Application No. SDP15-00005 (Site Development Permit) and Administrative Adjustment of Standards

## STAFF REPORT

<u>Applications:</u>	Project No. PRJ14-00051 Site Development Permit: SDP15-00005
<u>Project name:</u>	Gateway Senior Housing
<u>Staff Contact:</u>	Amy Tarce, Senior Planner Development Services Department. 425-837-3097 <a href="mailto:amyt@issaquahwa.gov">amyt@issaquahwa.gov</a>
<u>Applicant:</u>	The Wolff Company 911 East Pike Street, STE 310 Seattle, WA 98122
<u>Owner:</u>	Issaquah Gateway, LLC 911 East Pike Street, STE 310 Seattle, WA 98122
<u>Request:</u>	Site Development Permit <b>approval</b> for a 146-unit 5-story senior apartment building on 6.09 acres. The site includes approximately 1.8 acres of creek and wetland buffers, reducing the developable area to 4.29 acres. The project includes a community garden, dog run and outdoor seating area for the residents. The project proposes 78 parking spaces for residents and 32 spaces for employees. A community garden, swimming pool, social room, dog run and outdoor seating connected to a nature trail are provided as private community spaces for the future residents. Existing critical area buffers will be enhanced. Site

**Fig. 7. Newport Way Frontage Improvements showing a 10-foot bike-pedestrian facility and 5-ft. tree planter strip**

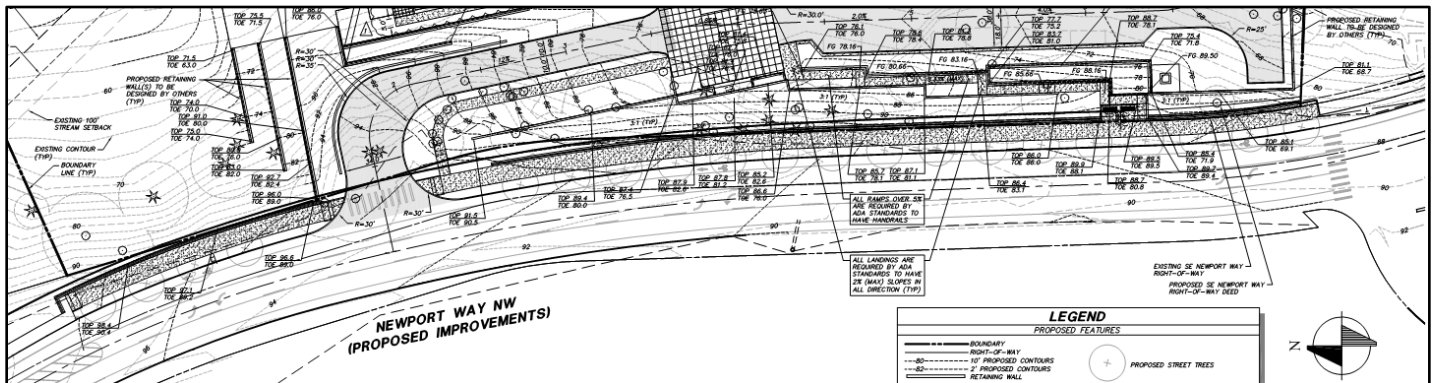
An Administrative Adjustment of the Parkway Standards for sections of Newport Way west of SR 900 is applied to the frontage improvements for the Gateway Senior Housing project. The AAS is for the reduction of the travel lane from 11 feet to 10 feet. All other variations shown below are required improvements per the Transportation Impact Analysis for the project, and consistent with the reduction of the speed limit on Newport Way to 30 mph.

The Newport Way half-street improvement required for this project includes the multi-use regional trail facility in lieu of the required sidewalk. Transitions to the existing facilities are shown to commence outside the frontage boundaries, according to City requirements.

[Condition 5] *With Site Work construction permits, the applicant will be required to provide a center median treated either as a landscape planter or turn lane, where appropriate.*

**Fig. 8. Missing Sidewalk of Proposed Neighborhood Street**

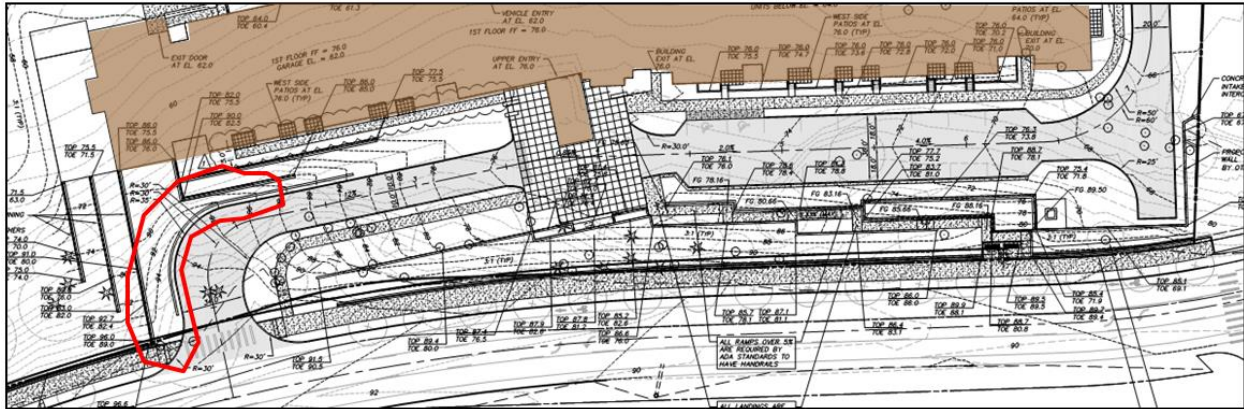
Neighborhood Streets are intended for low to moderate traffic volume. A neighborhood street with street trees, planter strips and sidewalks is proposed to serve the interior of the property, as prescribed in Fig. 6A. The proposed street design complies with the intent of the CIDDS, and provides the required elements for a Neighborhood Street identified in CIDDS 6.4.E (see sheet A0100), except for the section closest to the Newport Way connection. At this section (north), the eastern sidewalk is not adjacent to the travel lane and is separated by a large landscaped area. However, it is located where pedestrians are best served – close to the entries of the ground floor residential units. The sidewalk, however, does not connect back to the sidewalk on Newport Way (See circle depicting missing sidewalk connection in Fig. 8 below). The Applicant has requested an Adjustment to the Circulation Facilities standard for the Neighborhood Street to adapt the elements of the Neighborhood Street to the site constraints and the user needs.

**Fig. 11. Detail of Sidewalk at Northwest Façade of Building**

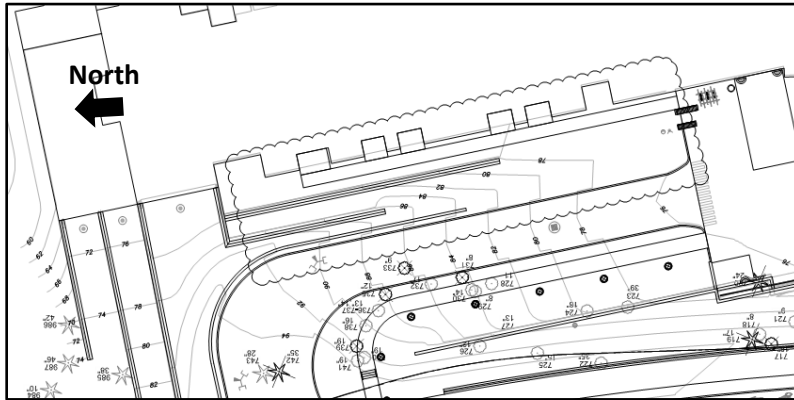
Landscape treatment of the walkway to the ground floor units along the northwest façade of the building should be refined to provide visual cues that this sidewalk does not connect to other parts of the site. The sidewalk serving the ground floor units of the north wing of the building terminates on what appears to be a large landscaped area. This area should be designed such that visitors and non-residents know this sidewalk is not a primary connection to other community spaces on site. At the same time, the walkway serving the ground floor units on the northwest side of the building needs to terminate gracefully and not to a blank wall. This area should be well-lit with natural and artificial light, and provided with attractive landscaping that engages the senses, so that it is comfortable, safe and can be easily monitored informally.

[Condition 7] *The pedestrian circulation area serving the ground-floor units of the north wing of the building shall be designed such that visitors and non-residents know the sidewalk is not a primary connection to other community spaces on site. At the same time, this area should be well-lit with natural and artificial light, and provided with attractive landscaping that engages the senses, so that it is comfortable, safe and can be easily monitored informally. The retaining walls shall be softened with landscaping or designed as an art wall.*

**Fig. 12. Diagram showing how the Neighborhood Street (green) should be oriented to the adjacent property and the driveway (teal) should connect as a “T”**

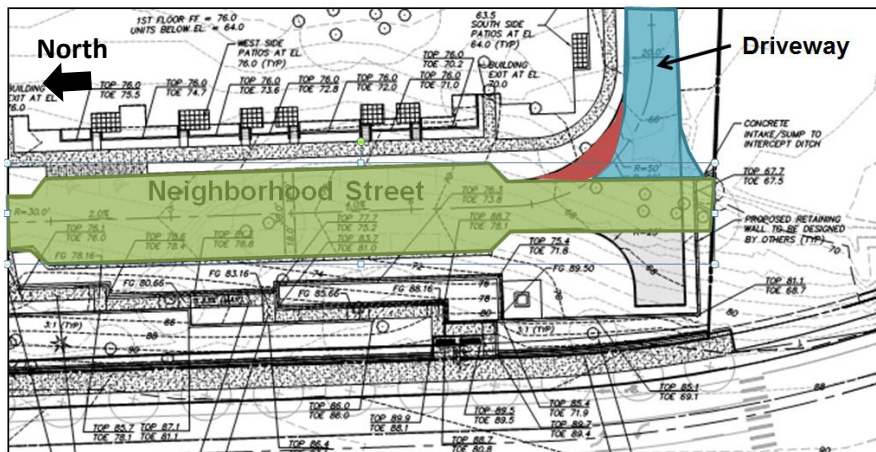
Another area where the function of the Circulation Facility is not clear is at the connection of the driveway serving the parking lots to the Neighborhood Street. The driveway is designed as a continuation of the travel lane of the Neighborhood Street, so that the Neighborhood Street appears to continue down to the parking lot. While the landscape treatment from this point changes in character, i.e. no street trees between the sidewalk and the travel lane, the road pavement itself is designed to continue as one facility. Reconfiguring this

connection as a “T” and redirecting the Neighborhood Street to continue south to the adjacent property, would be the appropriate treatment for this section (see Fig. 12). This can also reduce the amount of pavement and increase the pervious area (red area in Fig. 12) for a more pleasant pedestrian experience.

*[Condition 8] Reconfigure the driveway connection to the Neighborhood Street, using changes in grade, paving and other visual cues, to signal to pedestrians and motorists that they are entering a driveway and that the Neighborhood Street will connect to the adjacent property.*

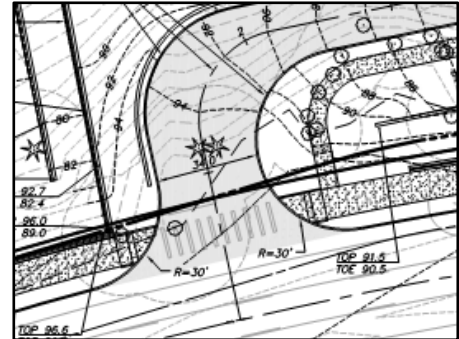
The Neighborhood Street travel lanes are 10-feet side each way, while the connection to Newport Way has a width of 36 feet. Subsection 12.3.B requires motorized facilities to be designed to the minimum pavement to reduce automobile speed while still being functional. This standard should be combined with 12.3.C, Pedestrian Safety Measures, when determining the design of the connection between the Neighborhood Street to Newport Way, and the connection of the driveway to the parking lot from the Neighborhood Street. As proposed, the connection of the Neighborhood Street from Newport Way is shown at 34 feet, which is the maximum allowed in the City’s Street Standards. The Applicant proposed the 34 feet width opening accounts for the steep grade and turning movement of fire trucks. To comply with the standard, the width of the Neighborhood Street intersection at Newport will be reduced for everyday use by private vehicles, while maintaining functionality for trucks including fire, garbage, delivery, and moving.

*[Condition 9] Reduce the width of the Neighborhood Street driveway at Newport Way to the minimum required for private vehicles while using techniques that maintain functionality for the various larger vehicles accessing the site.*

**Fig. 13. Crosswalk paving in the parking lot**

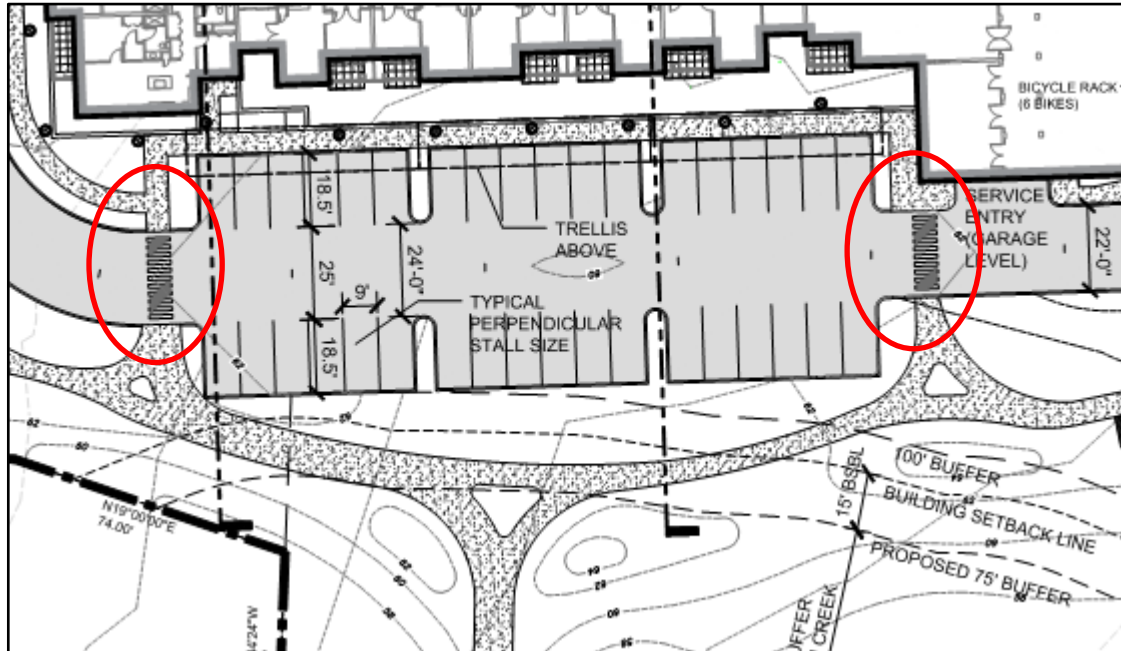
Pedestrian crossings are wide and provided with special texture when they are in vehicular areas. Pedestrian crossings for the gravel-paved pedestrian-only circulation facility adjacent to the Schneider Creek open space is provided with the standard reflective paint striping. 12.4.E.2 requires change in material or pedestrian tables.

[Condition 10] Consider using City Street Standard T-37, Crosswalk Stripe for Decorative Pavement, at pedestrian crossings in the interior of the lot.

**Fig. 21. Garage man door and walkway**

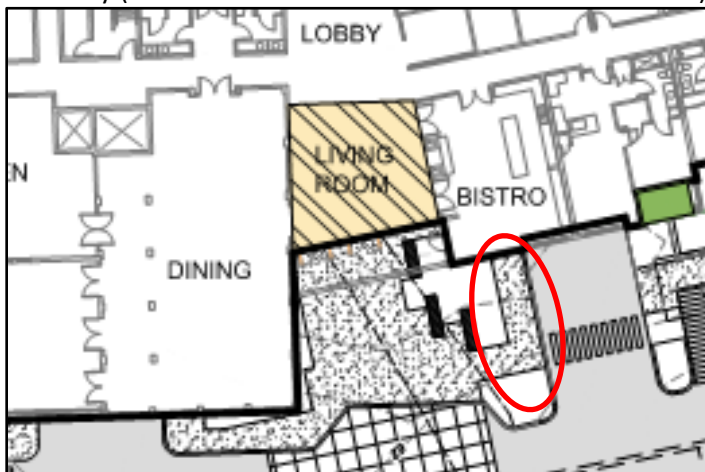
The community spaces are integrated into the more functional elements of the site such as circulation, critical area buffer and noise mitigation and buffer from the traffic on I-90 and Newport Way. The walkway to the garage man door is shown next to the driveway and separated from the planter area with low seat walls of the plaza (See Fig. 21 below). This walkway could be re-oriented to turn right from the man door and connect to the plaza, so that the pedestrian is directed to the plaza, and not to the driveway. This better integrates the pedestrian circulation facility with the outdoor plaza and also enhances pedestrian safety by providing a greater separation between the walkway and the garage driveway (see related standards in CIDDS15.3.E and 12.5.E)

[Condition 12] *Re-orient the walkway to the garage man door to integrate with the plaza and to separate pedestrians from the driveway to the garage. Move landscape adjacent to the garage driveway.*

**Fig. 22. Site concept detail for the area of the site visible from Newport Way (from sheet L1.05)**

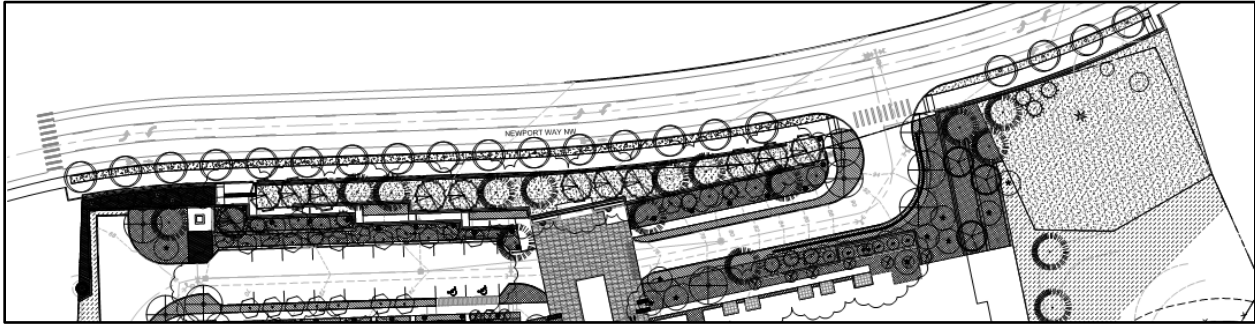
The architecture of the buildings and trees are primary elements used to define the public realm; the I-90 edge of the property is designed to have lush landscaping consistent with the Western Gateway vision and the Mountains-to-Sound Greenway. The Newport Way landscaping provides a pedestrian entry, with seating and flowering trees, and vegetation along the whole frontage that allows the building to be seen from the street (see Figure 22 below). However, the landscaping includes evergreen trees that block the view of the building and does not evoke a "Gateway-to-Issaquah" character. The orchard and community garden adds a horticultural theme to the project, while the concentration of community spaces along the Schneider Creek buffer signals that this senior housing celebrates nature and its residents are encouraged to connect to nature.

[Condition 16] *The landscape treatment along Newport Way shall emphasize the gateway-to-Issaquah function of this property. Plant trees along the eastern edge of Newport Way that reinforces the character of the site. That is, use a more natural palette and placement north of the entry road and south of the ramp entry, and provide in the central area between the vehicular and ramp entries a more urban, regular, and primarily deciduous palette with evergreens selected to fit in the space available. The trees and understory vegetation for the length of Newport Way coinciding with the length of the building shall be designed as a “foreground” to the building, with the trees paired or staggered from the street trees and accommodate good sightlines into the site and building.*

**Fig. 25. “Northwest” Architecture Character (Kelkari Condominiums in Issaquah)**

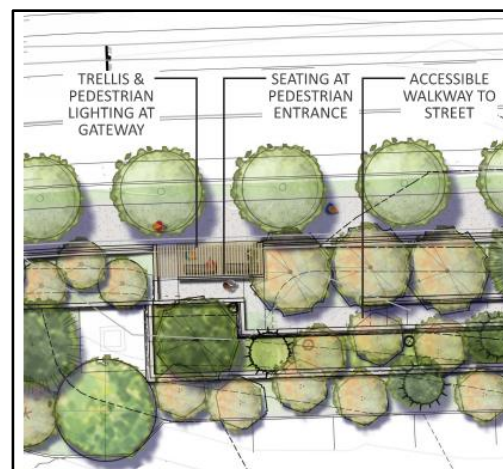
Timber trusses and stone base is incorporated into the architecture, consistent with the vision for the Western Gateway. However, the stone and timber trusses are applied to the bottom floor of the building, which is not readily visible from Newport Way. The building's top 2 floors are the most visible floor from Newport Way. Fig. 24 below shows the façade visible from Newport Way. The modulated roof, employing a series of dormers, shed and gables, and the windows at the center bay, hint at a “Northwest” character that was also featured in the Gateway Apartments. Fig. 25 shows an example of treatment of the top floor to a building that was referenced in the Gateway Apartments SDP review as achieving the intent of a “Northwest” architecture appropriate in the Western Gateway District of Central Issaquah.

[Condition 17] *The top floor of the building, which is the part most visible from Newport Way, should be further refined to create a strong architectural statement befitting the Western Gateway. Consider adding timber truss elements to the middle gable roof, or acceptable alternative reflective of the “Northwest” architecture example in Fig. 25 of the SDP staff report.*
